18C Operator Interface Equipment Characterization

The information in this appendix of the reference ABWR DCD, including all subsections and figures, is incorporated by reference with the following departure and a supplement.

STD DEP T1 3.4-1 (Figure 18C-8)

Figure 18C-8 Overall Configuration of Operator Interface System

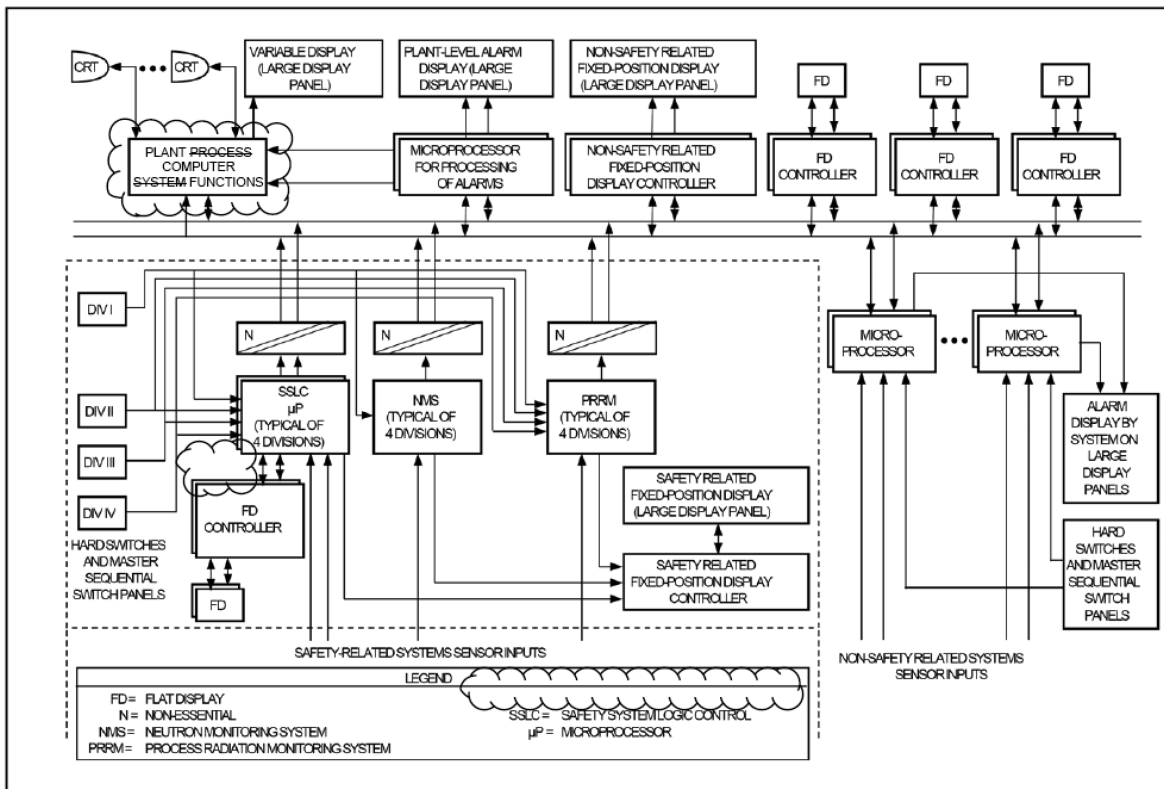
A characterization of the plant instrumentation and control systems architecture which supports the control room operator interface is illustrated in Figure 18C-8. As shown in Figure 18C-8, display and control capability for both safety-related and non-safety-related systems are driven by microprocessors which are independent of the redundant plant process computer functions. This assures the ability to safely shut down the plant in the unlikely event of computer failure. In the case of the safety-related systems, the microprocessors are divisionally dedicated and are each electrically isolated from the rest of the system.

The instrumentation and control systems architecture is not identical to the conceptual design described in Appendix 18C. The changes in the next paragraph reflect the architecture and configuration.

~~The plant wide, fiber optic Essential Multiplexing System (EMUX) provides the communications network for the system. This multiplexing system is actually a series of data acquisition and control networks, separate networks being provided for safety related and non safety related plant systems. The data communication function includes both safety-related and non-safety-related communication performed by separate networks as described in Section 7.9S.~~
